March 25, 2020

**RE: Concar Passage**

## CHANGES MADE FOLLOWING THE PLANNING COMMISSION STUDY SESSION

**STUDY SESSION LEVEL 3 PLAN**

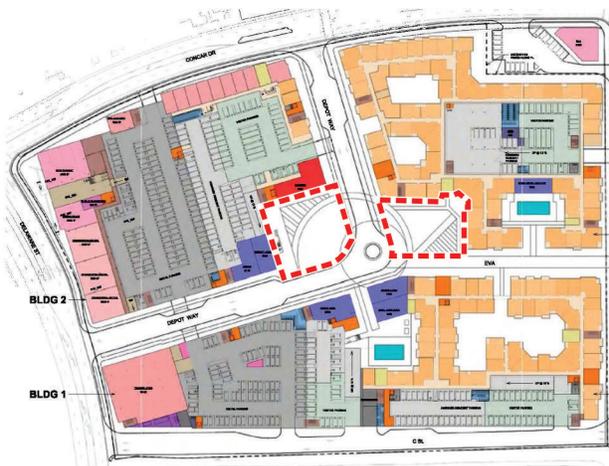
1. *Would like to see more setbacks from the public right-of-ways - overbearing if too close to the street.*
2. *A reduction in the number of buildings would be desirable.*
3. *Prefer a less dense project with some increased variation in building heights and setbacks.*

- *The number of buildings or floor area has not been reduced, but the building mass has been visually reduced somewhat by separating the two buildings on the eastern half of the project more.*

**STUDY SESSION LEVEL 1 PLAN**

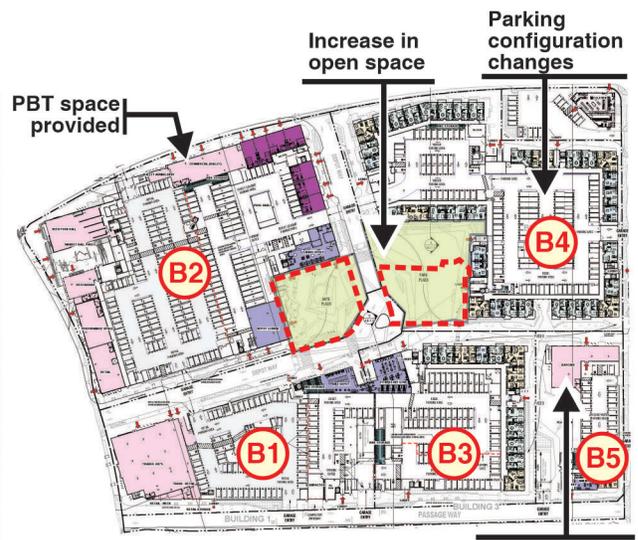
1. *The open space is not well sized to be useful - especially when Depot Way is proposed to run through it.*
2. *A larger open space would be desirable.*
3. *Would like to see better developed open green spaces.*
4. *Internal open space should be visible to the surrounding community, and should have things to activate the space and attract neighboring residents.*

- *The central open space has been enlarged.*
- *Improvements have been made to provide a more gradual transition from the Central Open Space to the podium level of Building #2.*
- *Substantial refinements have been made to the landscape details with the open space divided into an active Arts Plaza adjacent to Building #2 and a more passive Park Plaza adjacent to Buildings #4.*
- *The internal podium level plazas have been refined.*

**CURRENT SITE PLAN**

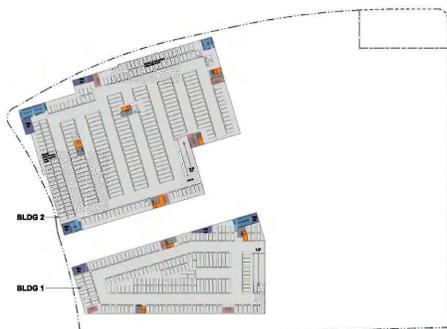
1. *Courtyards appear small.*

- *Courtyards have been increased in size*

**STUDY SESSION BELOW GRADE PLAN**

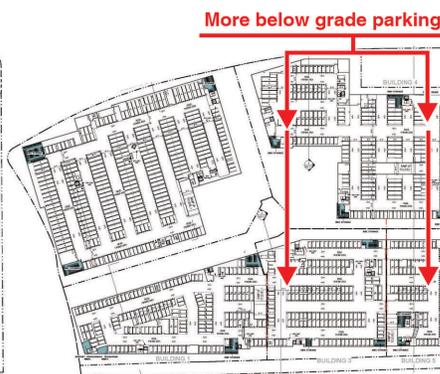
1. *More below grade parking would be desirable.*

- *More of the parking on the easterly half of the site has been relocated below grade.*
